# UNITED STATES PATENT AND TRADEMARK OFFICE

<b>Office Action Summary</b>	<b>Application No.</b> 10/648,387	<b>Applicant(s)</b> CATER, MIRO S.	
	<b>Examiner</b> Frederick C. Nicolas	<b>Art Unit</b> 3754

## DETAILED ACTION

Fig. 1

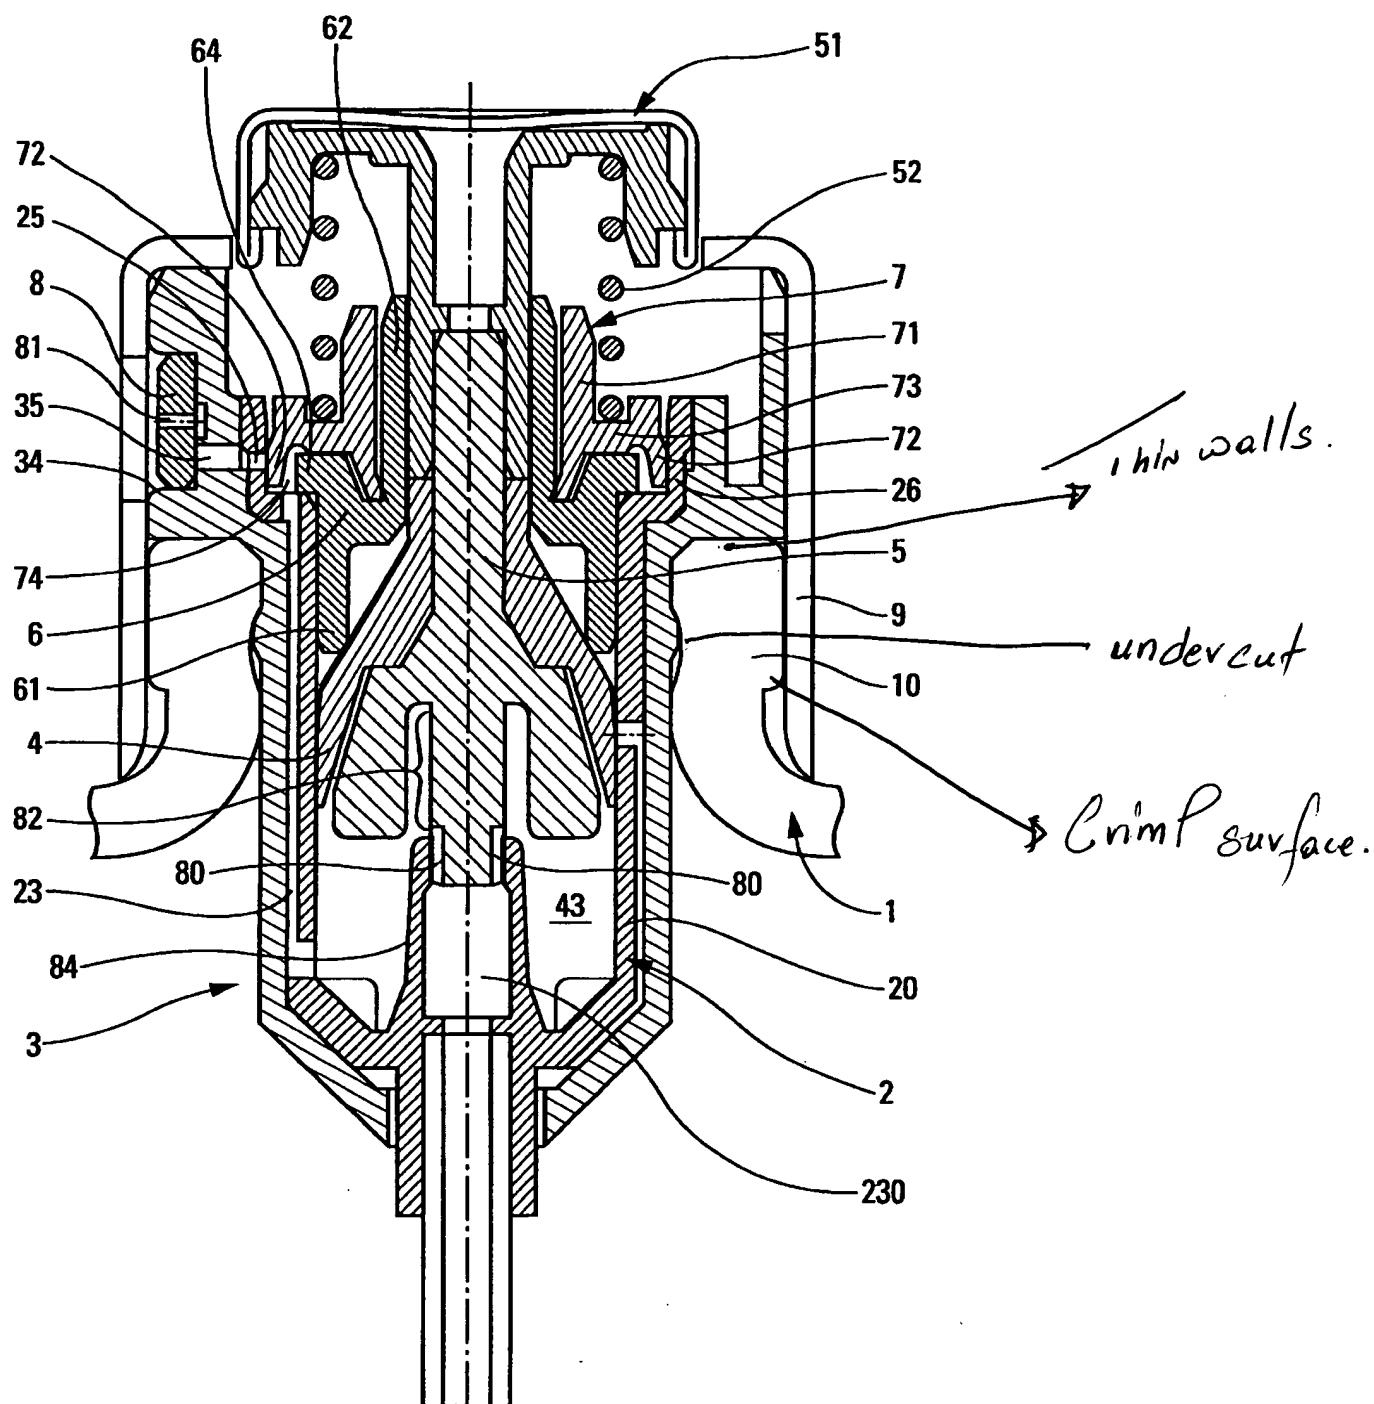
8. Claim 14 is rejected under 35 U.S.C. 102(e) as being anticipated by Garcia et al. 6,371,337.

Garcia et al. disclose a bottle (1), which comprises a body as seen in Figure 1, thin walls being formed around the opening (see Figure 1 for location of the thin walls, a thick section (10) spaced below the opening and forming an undercut (see Figure 1 for the location of the undercut), and a crimp surface formed on the outside of the neck (see Figure 1 for the location of the crimp surface).
